SAN ANTONIO WATER SYSTEM
Addendum No. 1
To
Construction Documents
For
2011 WATER & SEWER CONSTRUCTION PACKAGE III
SAWS WATER JOB NO. 11-5005
SAWS SEWER JOB NO. 11-5505
Solicitation #B-11-011-DD

**EXHIBIT OF PARKWAY SECTION
 LOOP 1604 EBFR
 9/22/2010
 C-1263.02**

M-12

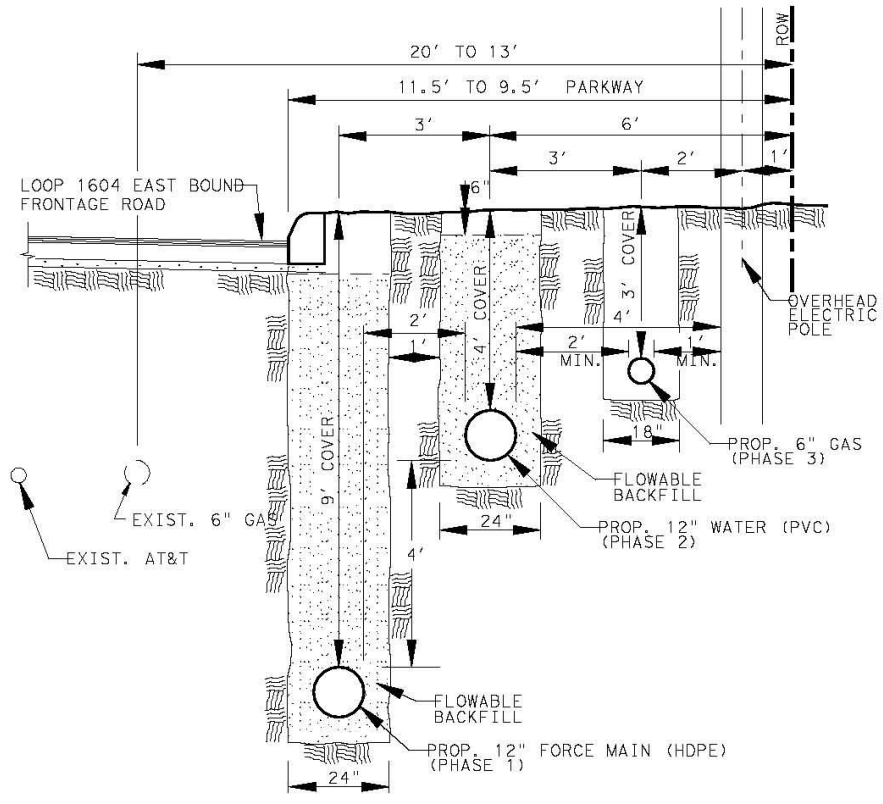
Add PAGE M-12

Add detail for US 281 N / Loop 1604 Interchange Project

Trench detail for separation distance between proposed main.

WQ15 On the 1604 & 281 work order, there is a note that states for us to see trench detail showing the separation between proposed mains. Where can we view the detail referenced in this note?

Response: *Yes, the detail provided within Addendum No. 1 will show the approximate amount of flowable fill that will be required for the US 281 / Loop 1604 Interchange project.*

Response: *The detail is being provided within Addendum No. 1*
